Subject: CERTIFICATE OF COMPLIANCE NO. 9297 FOR THE MODEL NO. TRAVELLER
PACKAGE: Submission of Revision 5 to the Safety Analysis Report (SAR)

This supplement revises license drawing 10006E58 to delete Sheet 1 for a 5 inch rod pipe and modify details for the 6 inch diameter rod pipe packaging and contents. In addition to increasing the weight limit for the 6 inch diameter rod pipe to 1650 lb (748 kg) in license drawing 10006E58 Revision 4, the item details were modified in Revision 5 of the license drawing. In addition Section 1.2.1.4 and Section 2.11.1 of the Safety Analysis Report are also revised to remove reference to a 5 inch rod pipe.

Drawing 10006E58, Rev. 5, "Shipping Package Loose Rod Pipe"

Drawing 10006E58, Rev. 4, "Shipping Package Loose Rod Pipe"

Figure 1-6 Rod Pipe (left) and Rod Box (right)

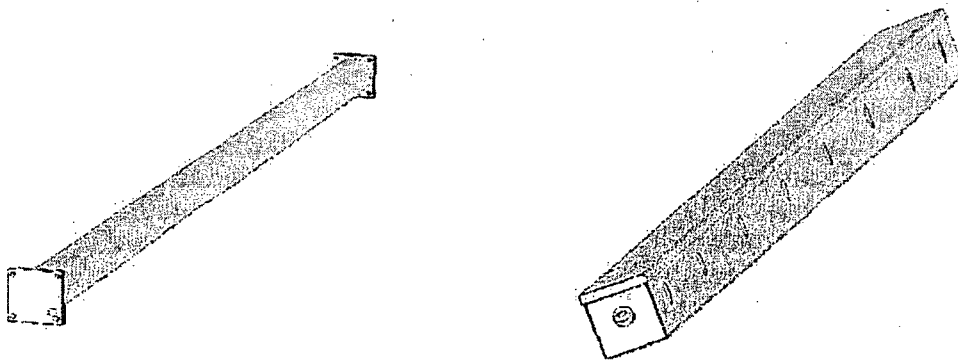
The Traveller is designed to carry loose rods using either of two types of rod containers: a rod box or rod pipe. Both can be seen in Figure 1-6. The rod box is an ASTM, Type 304 stainless steel container of rectangular cross section with stiffening ribs located approximately every 23.6 inches (600 mm) along its length. It is secured by fastening a removable top cover to the container body using socket head cap screws. The rod pipe consists of a 6" (15.2 cm) standard 304 stainless steel, Schedule 40 pipe, and standard 304 stainless steel closures at each end. The closure is a 0.25 inch (11.18 mm) thick cover secured with Type 304 stainless steel hardware to a flange fabricated from 0.25 inch (11.18 mm) thick plate.
